Environmental Review Team Report

Skyline Village

Plainfield, Connecticut

November 1984

Drainage Areas

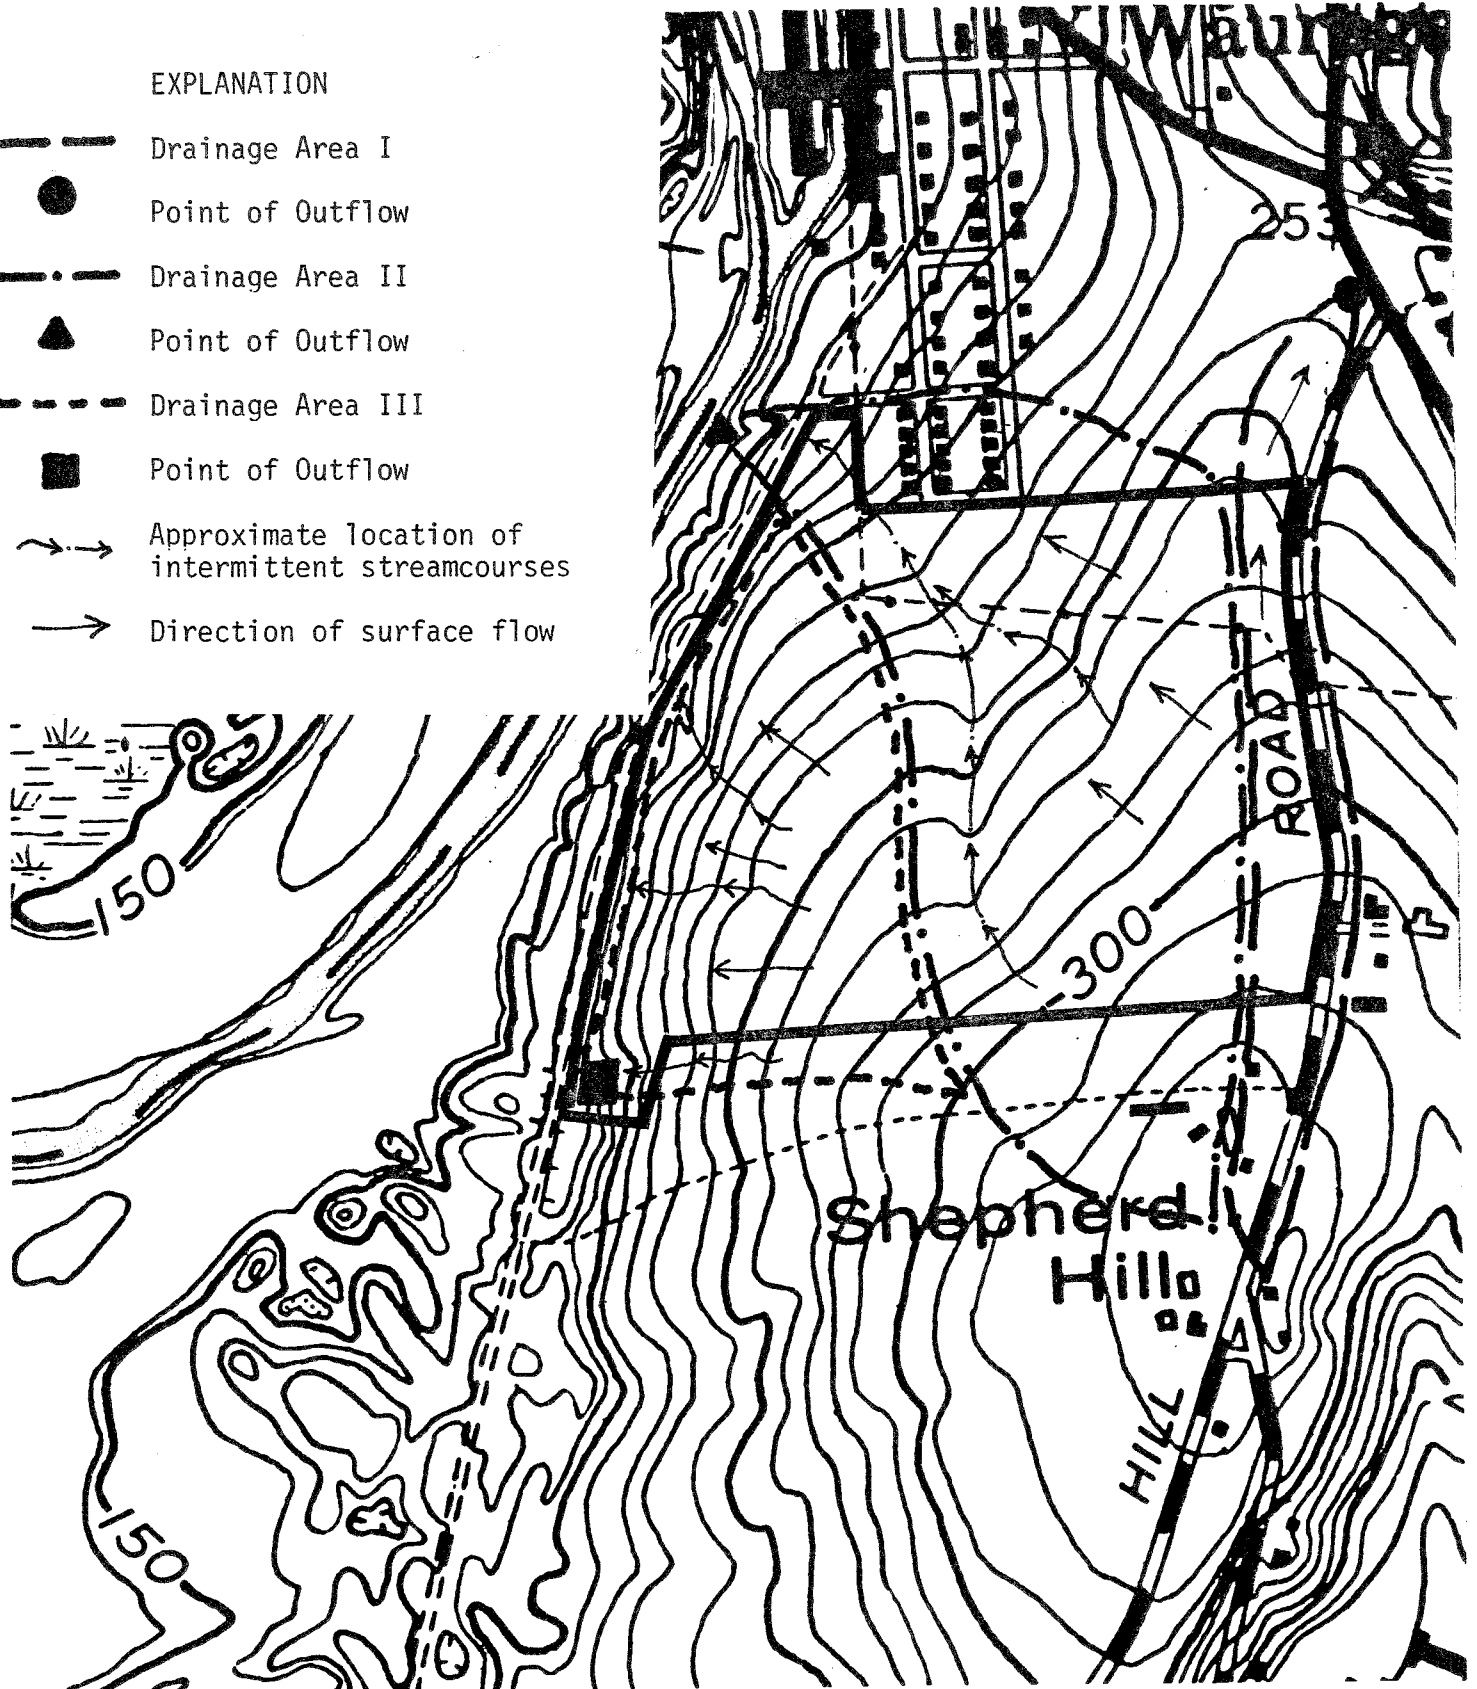
For the purpose of analyzing the anticipated runoff increases the parcel was divided into three drainage areas. These drainage areas are shown on the accompanying map. Each drainage area is based upon a certain point of outflow and shows all the land from which runoff ultimately reaches that point. It was assumed drainage area I, whose point of outflow is the inlet of the culvert near the intersection of Route 12 and Sheppard Hill Road, includes lots 1-12, drainage area II, whose point of outflow is at the Quinebaug River, includes lots 13-25, 46-62 and 70-104 and drainage area III, whose point of outflow is at the arched culvert, passing under the dirt road in the western limits includes lots 26-45 and 63-69. Also, it was assumed that surface runoff in drainage area III would flow downslope by sheetflow to the man-made ditch on the east side of the dirt road along the western limits. Once the water reaches the ditch, it would then be routed southward toward the arched-culvert. It should be pointed out that these estimates do not take into account potential drainage re-routing through man-made structures as well as other engineering measures.

As shown in Table I, the increases in runoff for drainage areas I and II would be under 7 percent following development. Runoff increases for drainage area II, however, are moderately high. Because of the moderate slopes present on the parcel and because of the large percentage of exposed soils (cornfields covering the property), even small increases could lead to severe erosion and sediment problems in some parts of the property. For this reason, it is recommended that these types of potential problems be addressed by formulating and following closely an erosion and sediment control plan for each phase of construction. Also, in this regard, it is recommended that disturbed areas be kept to a minimum and that lawns be established as soon as possible. Consideration should also be given to installing temporary sediment basins for each phase of development. This will hopefully reduce sedimentation problems to watercourses on and off the site as well as the Quinebaug River.

Prior to subdivision approval, it is recommended the applicant be required to submit detailed hydrological information on pre- and post-development runoff volumes and peak flows from the property for each phase of development. The project engineer should closely examine existing culverts, which may be affected by the proposed development. All storm drain outlets should include a designed energy dissipater to help protect areas below outlets from gullyng.

SOIL MAP

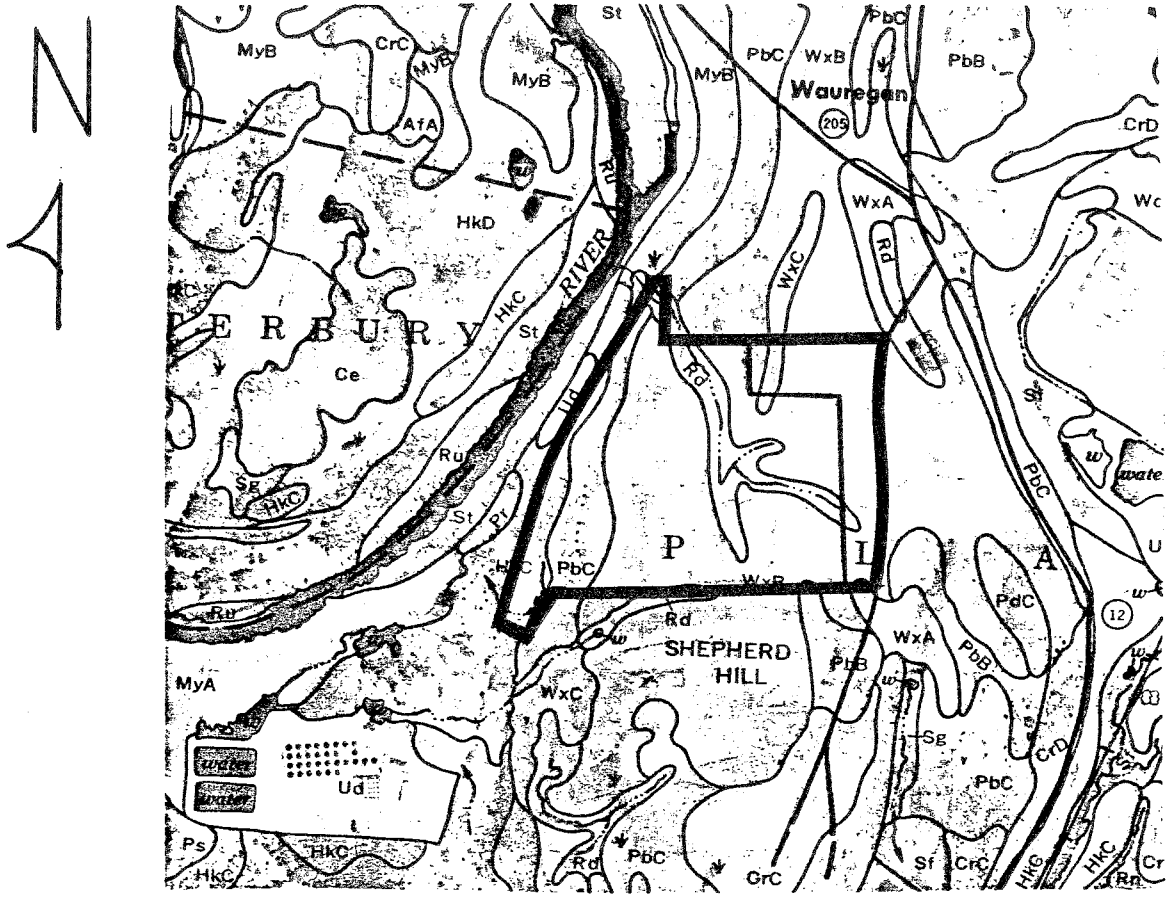
Overlying till in the central parts of the site are seasonally wet areas. These regulated inland-wetland soils are delineated by the symbol Rd (Ridgebury fine sandy loam) on the accompanying soils map. Any disturbances and/or modification of these soils will first require a permit from appropriate town officials.

In this regard, regulated inland-wetland soils on the property should be mapped by a certified soil scientist and the boundaries superimposed on the subdivision plan.
